Product Change Notification

Product Change Notification: P-26-030583**PCN Date:** 23-JUN-26**Customer:** Premier Farnell UK Ltd (PFUK) (101113)**Location:** Leeds**Agreement:** Agreement Unknown

070 MLC W-W 4P Plug Hsg(PN:174922-1,2,7)

► 070 MLC W-W 4P Plug Hsg Additional Tooling

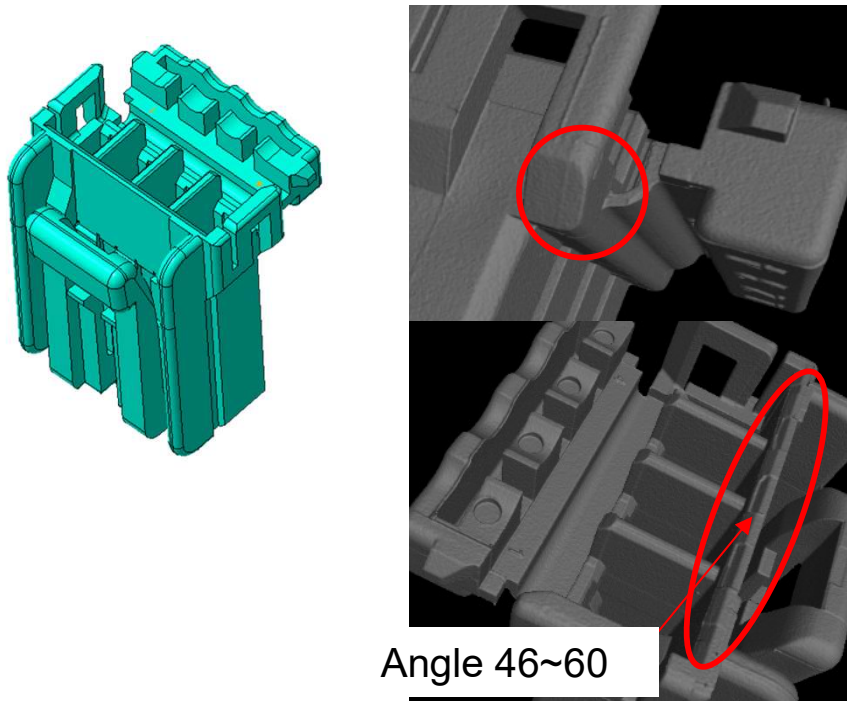
- 1. Part No : 174922-1,2,7
- 2. Description : 070 MLC W-W 4P Plug Hsg
- 3. Reason : CAPA Issue
- 4. Change Information : New Additional Tool

Appearance differences

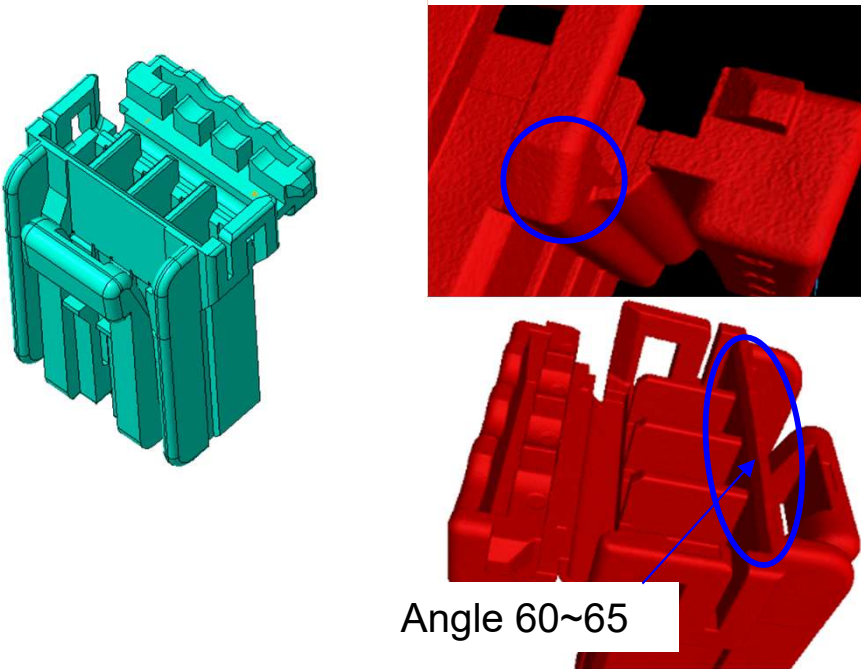
Before

Mold Quantity : 2 Molds
CAVITY : "J,K,L,M,N,P,R,S,T,U,V,W,
· (1dot) A,B,C,D, J,K,L,M,N,P,R,S"

Angle 46~60

After

Mold Quantity : 3 Molds
CAVITY : "··(2dot) A,B,C,D,E,F,G,H,J,K,L,M,N,P,R,S"

Angle 60~65

※Reliability Test Result: No Issue
